Feedthrough documented here: **D1800038: D5-1D1 Flange**
Accuglass 25D-5CX2-450 Part # 100522
 See **FRS 9869 - Fix leak in HAM6 D5 Feedthrough**

Typical In-vacuum RFPD ASC (Wavefront Sensor) Wiring Chain

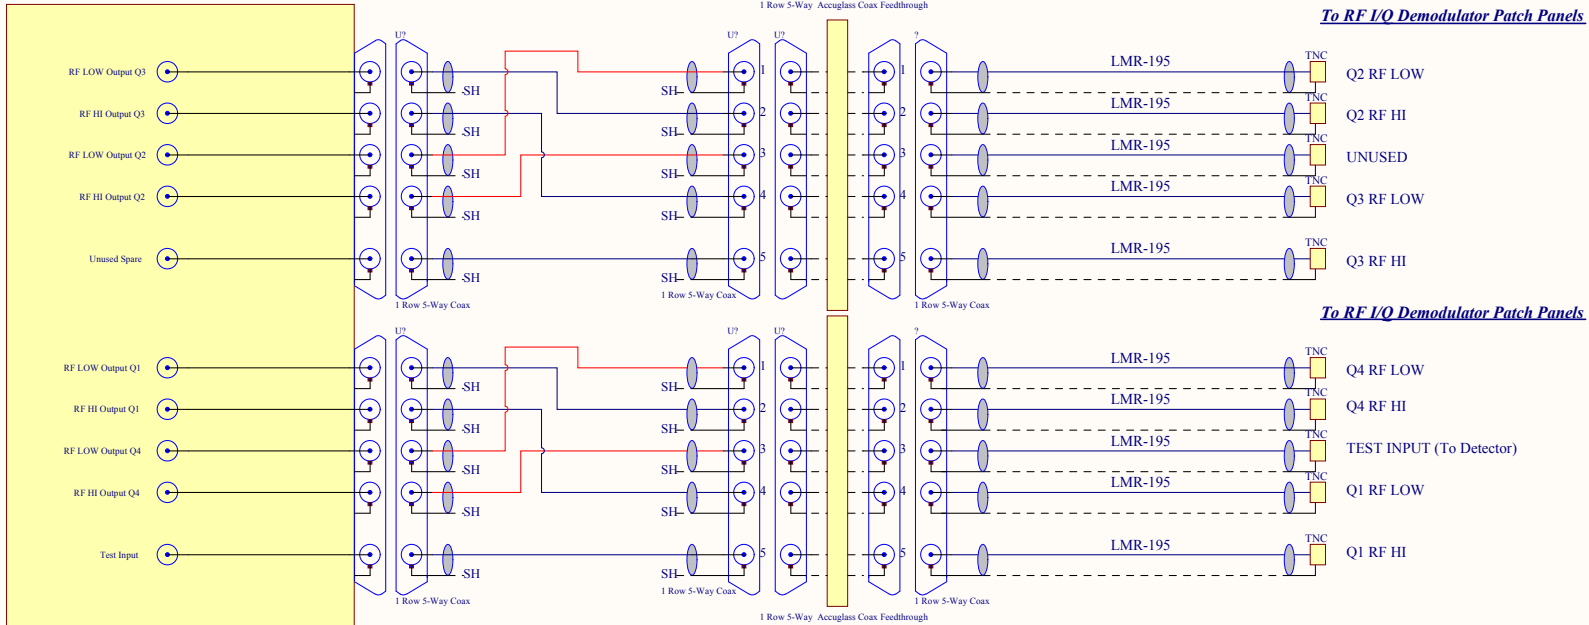
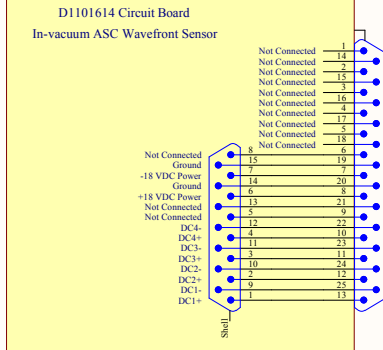
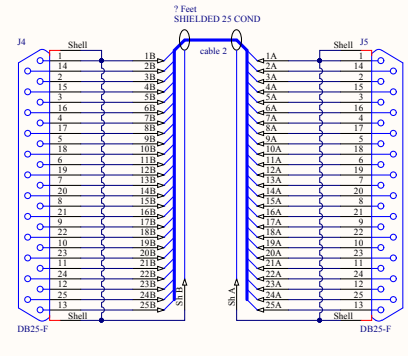
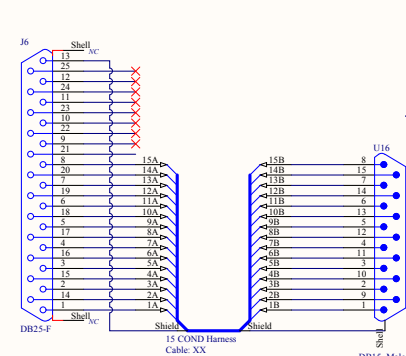
Version 1 - Initial Release
 Version 2 - Revised pinout to reflect the nonsensical way the single row coaxial 5-way D-sub was pinned in another conflicting, but older document.
 Version 3 - Added not so it's easy to tell which side to look at for the connectors.
 Version 4 - Updated for switch to Accuglass single row 5-way connector
